ITEM: Case No. PUD-000518-2024

LOCATION: 600 Tech Court

REQUEST: Approval of Resolution 9, Series 2025, recommending approval of a Planned Unit Development Amendment to install solar canopies and perform other exterior alterations to the property at 600 Tech Court with waivers to yard and bulk standards and the sign code.

**RESOLUTION NO. 9
SERIES 2025**

Proposed solar canopies over parking lot (above) and rear loading dock (left).

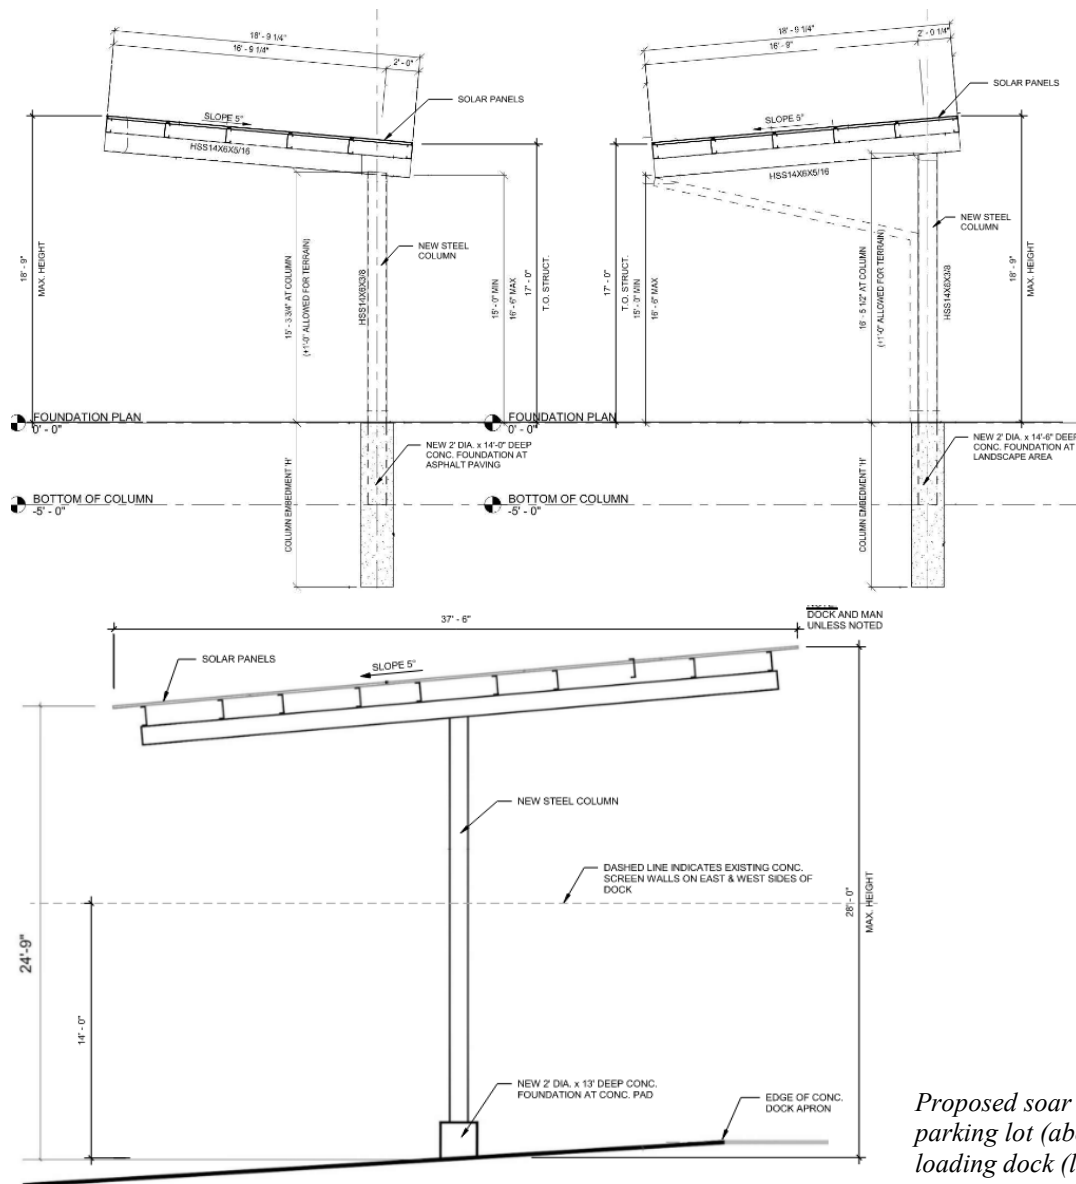
The solar canopies in the rear truck court will be 28 feet tall and 37.6 feet wide. The canopy columns will be spaced approximately 18 feet apart. All canopy posts will be set in concrete at a diameter of 2 feet and a depth of 13-14.5 feet.

The proposed solar canopies will not obstruct existing drive aisles, parking spaces, or vehicle circulation. The canopies located in the front parking area provide a minimum of 15.3 feet in clearance height. The average height of a pedestrian vehicle ranges from 4.5-6.5 feet, providing adequate clearance from the canopy structures.

The solar structures located along the rear loading dock reach a maximum clearance height of 24.5 feet. The average maximum height of a tractor trailer is 13.5-14.5 feet, providing adequate clearance. The 18-foot post spacing will not interfere with the circulation of tractor trailers around the truck court.

- A maximum of 25 feet in height is allowed for accessory structures in the industrial zone. The proposed maximum height of the solar canopies located in the rear truck yard is 28 feet. The rear canopies exceed the maximum height to allow for additional clearance for semi-trailers that use the loading area.

Landscape plan showing tree removal (red) and some new tree placement (green).

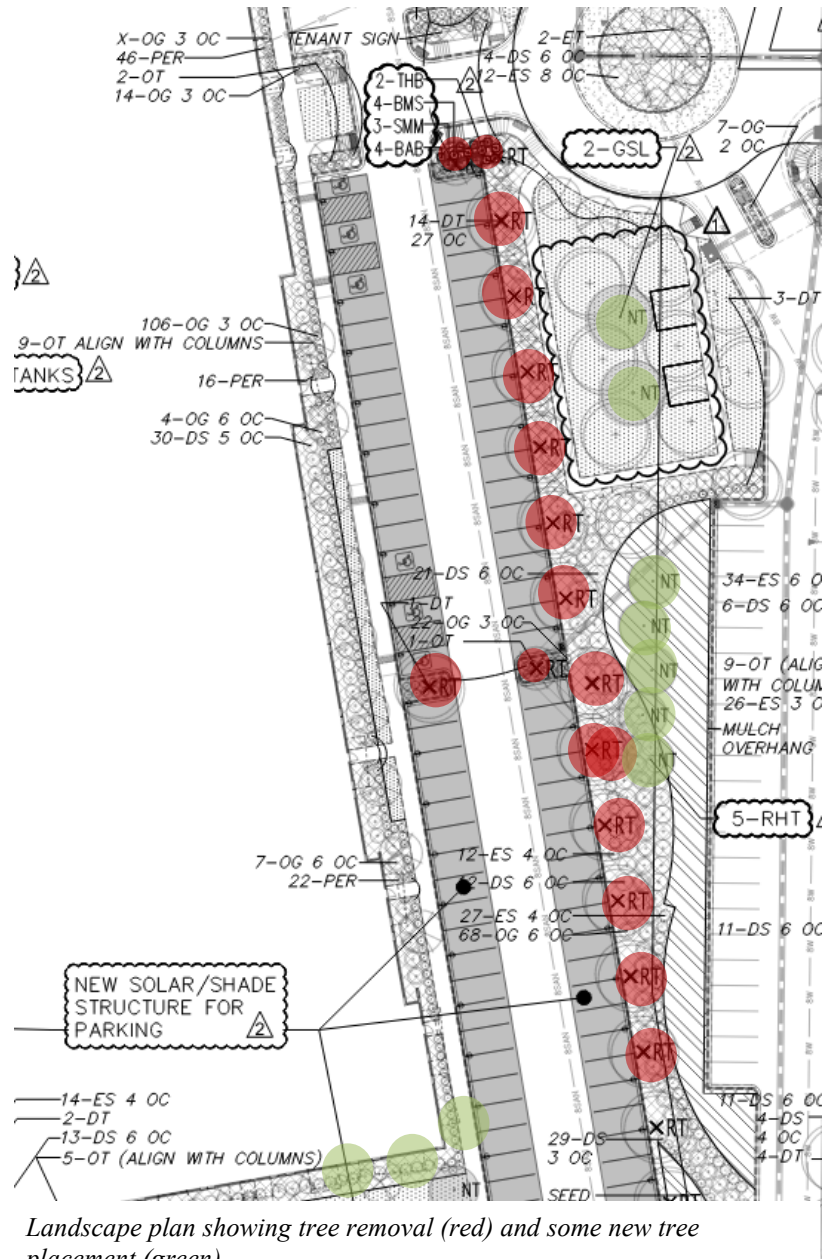
Twenty trees will be removed with this proposal. Nineteen trees will be removed from the southwestern parking area and one tree will be removed from the mechanical yard. Twenty new trees will be planted on the property in existing landscaped areas. The 19 proposed tree removals are to provide clear access for the solar canopy structures and the tree removal from the mechanical yard will provide additional space for the proposed tanks.

The minimum amount of landscape coverage required within an overall development is 25%. The Louisville Corporate Campus at CTC PUD provided 37% overall landscape coverage upon its original approval, and the proposed PUD Amendment will maintain the same coverage. Twenty deciduous and ornamental trees are proposed to be removed from the site. Twenty new trees of similar size and species are proposed to be planted in existing planting areas. The removed trees will provide an unobstructed area for the solar canopies, avoiding concerns of potential fire hazards and future tree overgrowth.

Two of the 20 trees are proposed to be removed from the front entrance area. New shrubs and ornamental grasses will be planted in the front entrance bed to maintain diversity in height and size of entry landscaping.

3 SOLAR/SHADE CARPORT @ PARKING LOT
SCALE: 1/4" = 1'-0"

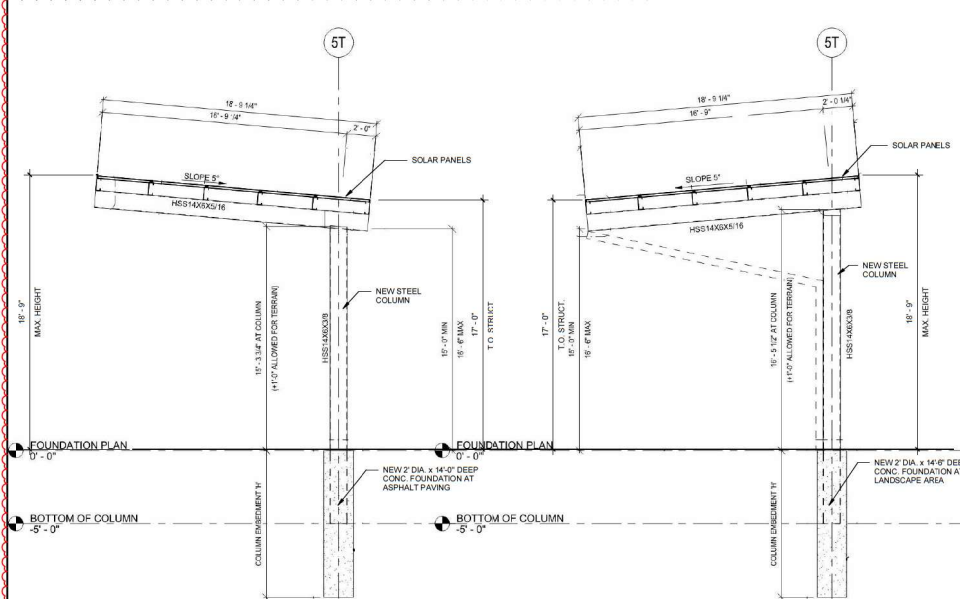
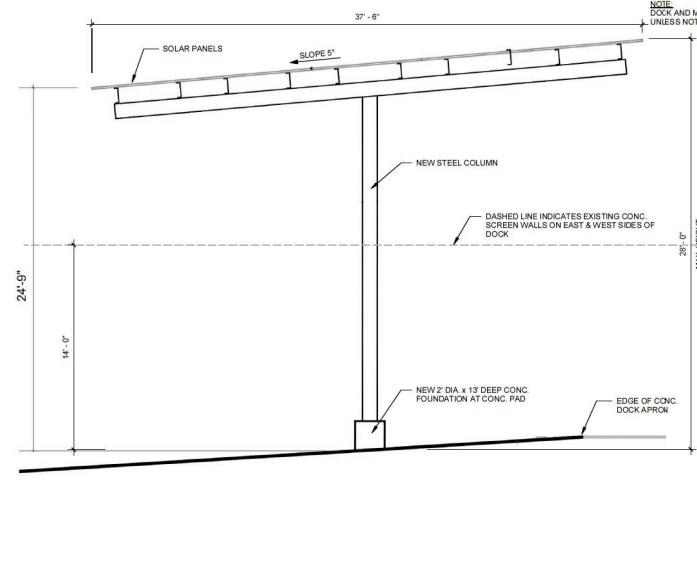
- Front yard setbacks for accessory uses must be a minimum of 30 feet in the Industrial zone. The applicant is requesting a minimum 10-foot front setback for the solar canopies. Accessory uses typically require setbacks in the front yard at a farther distance than the principal structure, encouraging accessory structures to only be placed behind the principal structure. Conversely, the IDDSG allows for front yard parking setbacks to be less than principal structure setbacks, encouraging parking areas to be in front of the principal structure. The requested waiver would allow for the canopies to function as both a solar energy collector and shaded parking for the building tenants.
